IREDELL COUNTY HEALTH DEPARTMENT

IMPROVEMENT PERMIT / AUTHORIZATION TO CONSTRUCT / OPERATION PERMIT / EXISTING SYSTEM INSPECTION

PERMIT# 100655 PIN# ~~4744-78-2448~~ 4744-89-4223 DATE 9-7-04

SUBDIVISION MARTHA STEPHENS BLOCK / SECTION ____ LOT 23 LOT AREA 2.105 AC SITE CLASS. PS DESIGN FLOW 420 L.T.A.R. .35

INITIAL SITE SKETCH

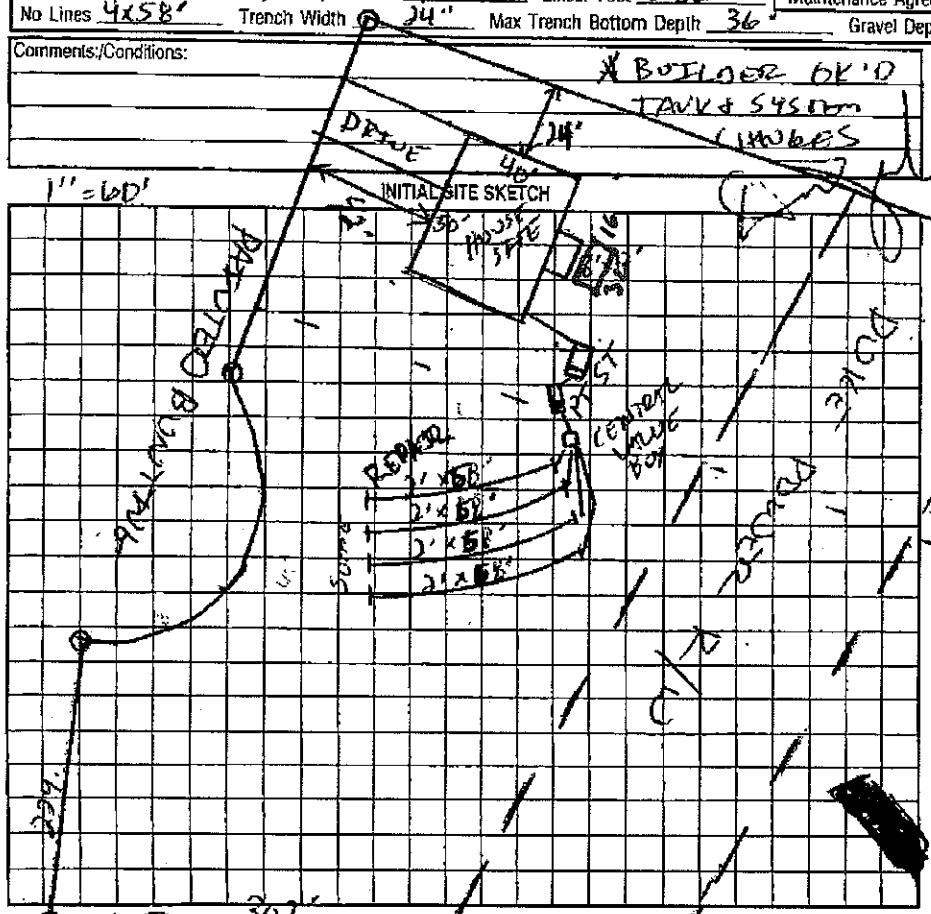
Comments/Conditions: * BUILDER OK'D TANK & SYSTEM LOCATIONS

Comments/Conditions: (1) THIS IS A REDRAW PERMIT, ONLY CHANGES WERE SYSTEM TYPE & BEDROOMS, PERMIT REDRAWN USING CRITERIA FROM PREVIOUS ISSUED PERMIT ISSUED BY BRADY FREEMAN, R.S. ON 10-5-01; SYSTEM WILL BE INSTALLED IN SAME LOCATION

AS BUILT SKETCH

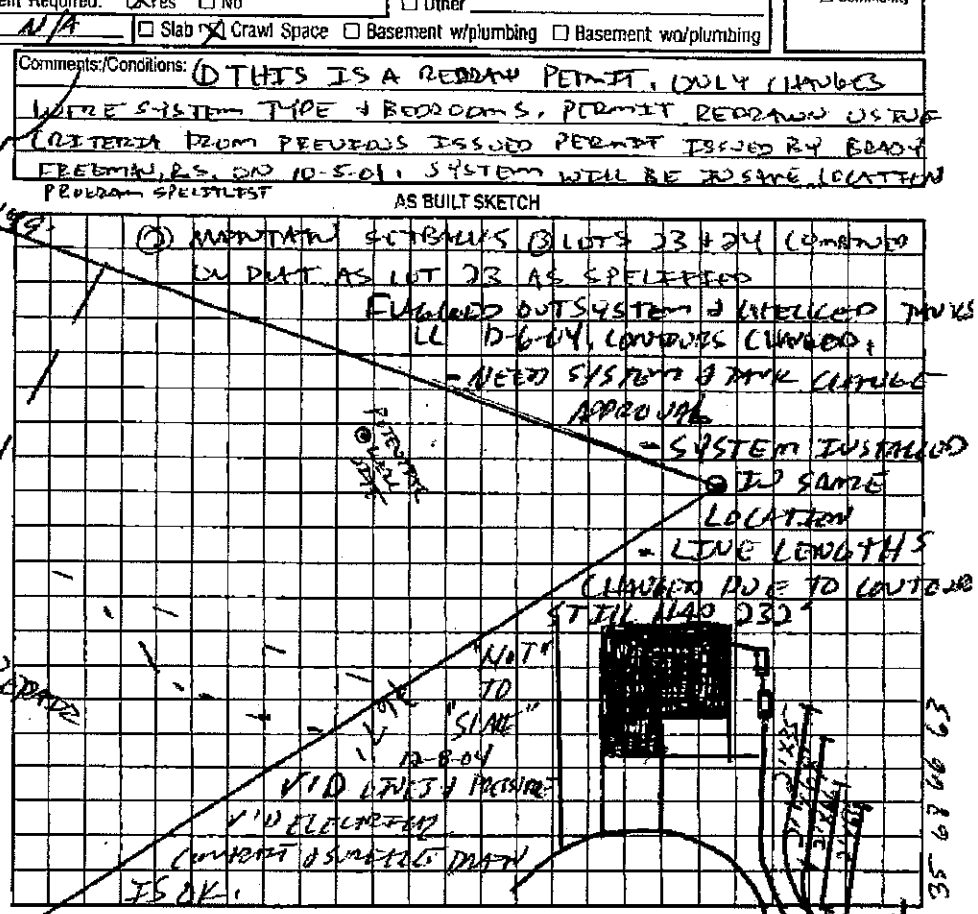
Location of the proposed 16'x32' inground pool addition does not appear to impact the existing on-site septic system.**NOTE:
